**COUNTY OF SAN MATEO  
PLANNING AND BUILDING DEPARTMENT**

**DATE:** October 14, 2015

**SUBJECT:** STAFF REPORT ADDENDUM: Consideration of a Major Subdivision, a Grading Permit, and certification of a Final Environmental Impact Report (FEIR), pursuant to the California Environmental Quality Act (CEQA), for the proposed Ascension Heights Subdivision located in the unincorporated San Mateo Highlands area of San Mateo County.

*Figure 1 – Original and Revised Access Road*

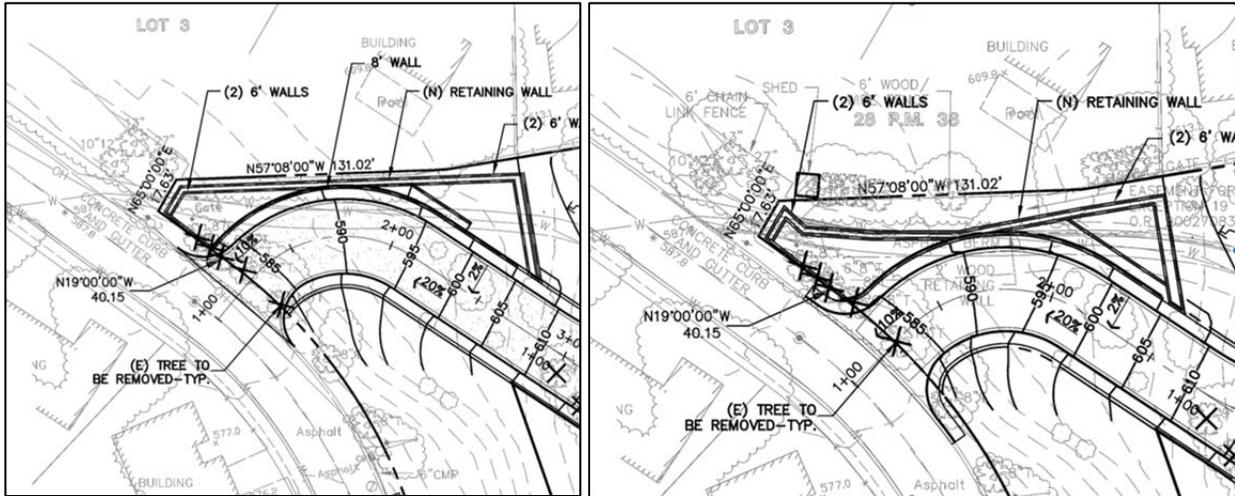
The applicant has revised the tentative subdivision map (Attachment C) to reflect changes to the road access from Bel Aire Road. The relocation moves the 50-foot private street, sidewalks and retaining wall 10 feet away from the adjacent property line, where the earlier plans reflected the retaining wall to be 1 foot from the property line. This modification is proposed in order to mitigate impacts to existing mature trees located on the adjacent parcel along the property line. See Figure 1 below.

Staff has determined that the modification does not present any negative impacts or changes staff's previous review on the project. No additional grading is necessary to accomplish the relocation, and retaining walls and drainage basins originally proposed will remain as proposed. The relocated roadway access should provide additional room as to mitigate impacts to the root structure of the trees located on the adjacent parcel.

Figure 3 – Maximum Building Height Measurement

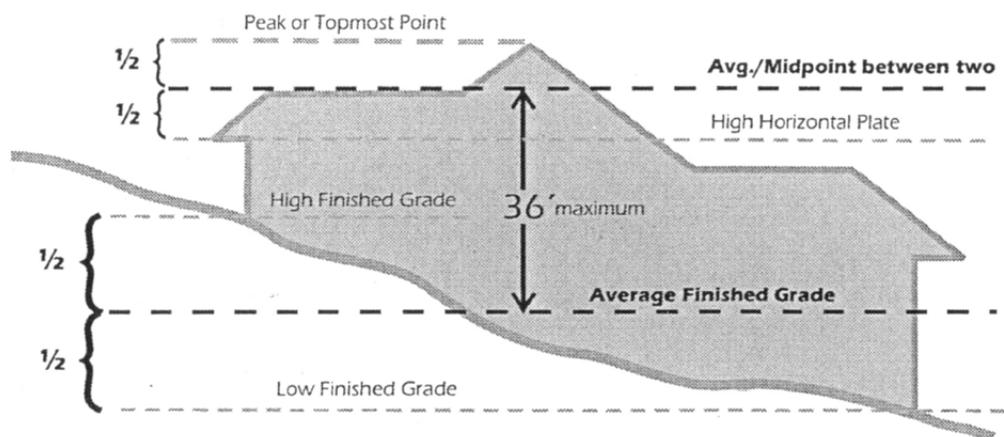
The project site is located within the R-1/S-8 zoning district, where the current height limitation is 36 feet. The method utilized to measure the height is an average taken from the average finished grade (average distance between the lowest finished grade to the highest finished grade) to the average roofline (average distance between high horizontal plate to peak or topmost point of dwelling). See Figure 3.

*Figure 4 – Proposed Height Standard for Subdivision*

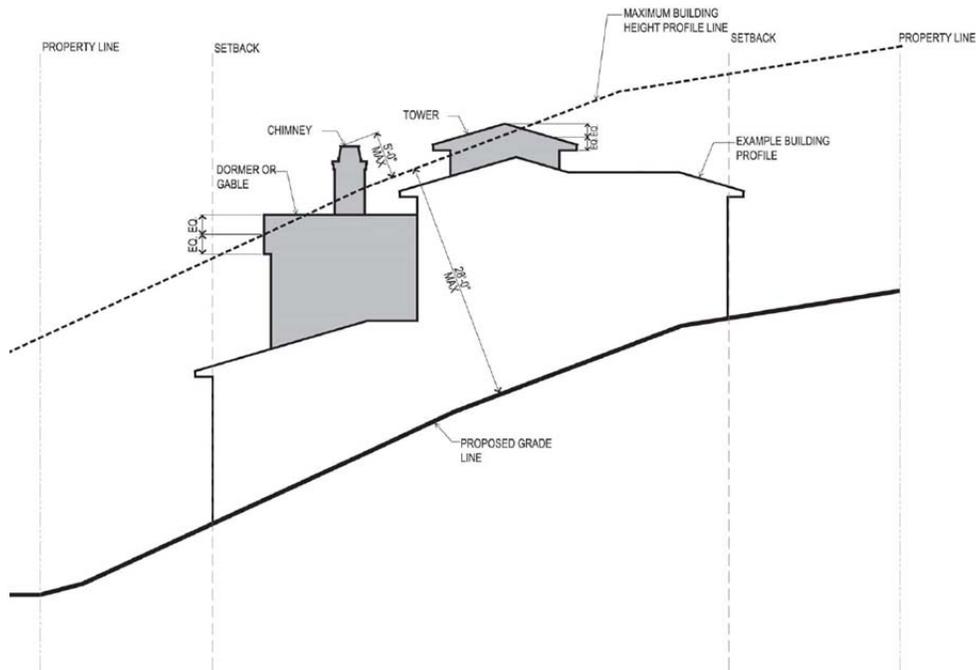
Concerns have been raised that this height limitation does not encourage articulation that is respectful of hillside topography, and may result in visually unappealing designs that could create large, massed dwelling profiles. Staff cannot require different standards for this subdivision than what is allowable within the zoning district. However, the applicant has proposed design guidelines that would voluntarily limit development within the subdivision to a maximum of 28 feet as measured perpendicular to the finished grade, allowing for certain architectural projections (such as chimneys, dormers or gables). See Figure 4.

In reviewing the submitted design guidelines, staff is in support of the lower height limitation proposed in order to promote development that is more sensitive to the topography and view sheds than the current zoning would require. While staff is obligated to review projects utilizing zoning regulations currently in place, in order to achieve the goals of the applicant's proposed design guidelines to reduce side wall massing, staff is proposing a condition that requires the applicant to record a deed restriction (Covenants, Conditions, and Restrictions) that requires development of the 19 lots be enforced per the proposed design guidelines (Condition 18).
